Replacement of BPD1159 with BPD2374

Bendix aims to streamline the designation of BPD1159 to BPD2374.

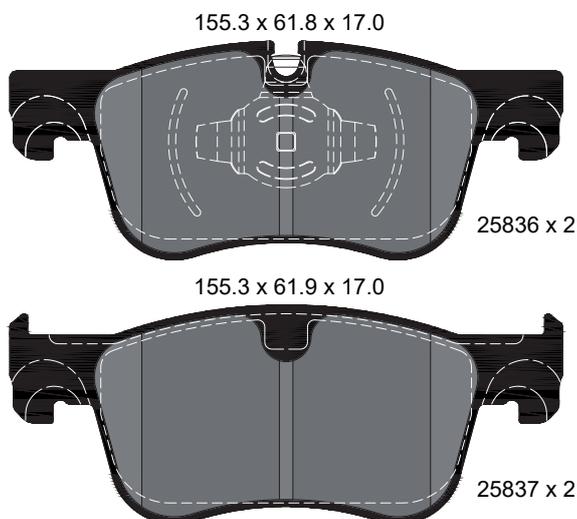
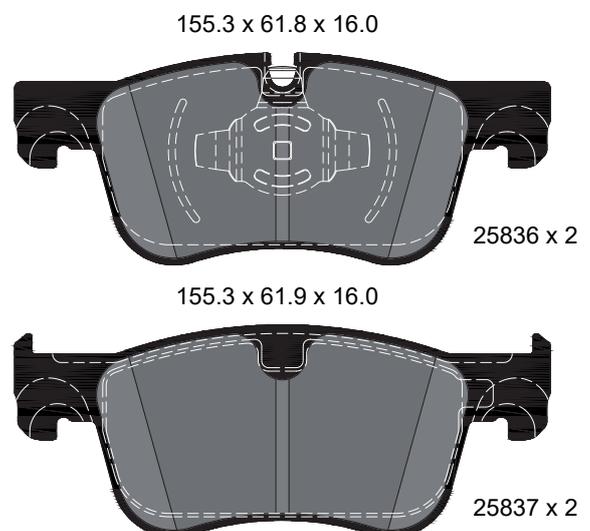
The difference between BPD2374 and BPD1159 is the BPD2374 thickness is slightly thinner, the chamfers will be modified from parallel to segment, and a foil cover will be applied to 25837 WVAs.
